Access Compliance Report

Public Rights-of-Way

(Curb Ramps)

Intersection ID: 13097	Main Street: BEAUMONT_AV	Cross Street: SUNNYSIDE_AV	Location: SW
ADA ID: DDA716ACC6D2	Ramp Type: PerpDiag	Initial Pass/Fail: Pass	Overall Compliance: No
Codes/Mitigation Info/Possible Solution		Field Measurements/Component Compliance

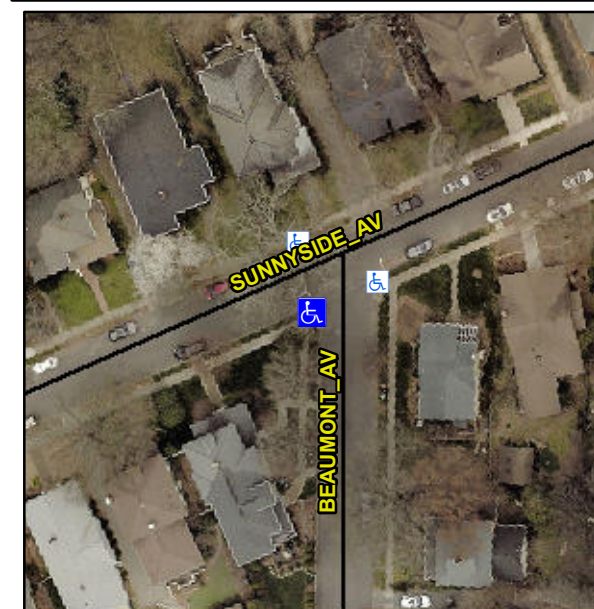
Not Found, R304.5.3, R305, R302.7.2

Compliance	Description	Data	Compliance	Description	Data
N/A	Ramp Length (in)	53.0	Yes	Ramp Slope (%)	5.7
Yes	Ramp Width (in)	60.0	No	Ramp XSlope (%)	2.1
N/A	Flare Type LT	None	N/A	Flare Type RT	N/A
N/A	Flare Slope LT (%)	N/A	N/A	Flare Slope RT (%)	N/A
N/A	Flare Traversable LT?	N/A	N/A	Flare Traversable RT?	N/A
Yes	Landing Length (in)	49.0	No	DWS Provided?	No
Yes	Landing Width (in)	61.0	N/A	DWS Contrast?	No
Yes	Landing Slope (%)	1.5	N/A	DWS Length (in)	N/A
Yes	Landing X Slope (%)	0.2	N/A	DWS Full Width?	No
N/A	Landing Curb? (Y/N)	No	N/A	DWS Offset (in)	N/A
N/A	Shared Landing?	Yes			
Yes	Gutter Ponding?	No	Yes	Gutter Slope (%)	4.7
No	Gutter Lip Ht (in)	0.5	Yes	Gutter X Slope (%)	0.2
N/A	Painted X Walk1?	No	N/A	Painted X Walk2?	No
	X Walk 1 Direction	To E		X Walk 2 Direction	To N
N/A	X Walk 1 Width (in)	N/A	N/A	X Walk 2 Width (in)	N/A
	X Walk 1 Slope (%)	5.6		X Walk 2 Slope (%)	1.9
	X Walk 1 X Slope (%)	1.5		X Walk 2 X Slope (%)	3.9

Remove & Replace Curb Ramp With Two New Directional Ramps or Equivalent.
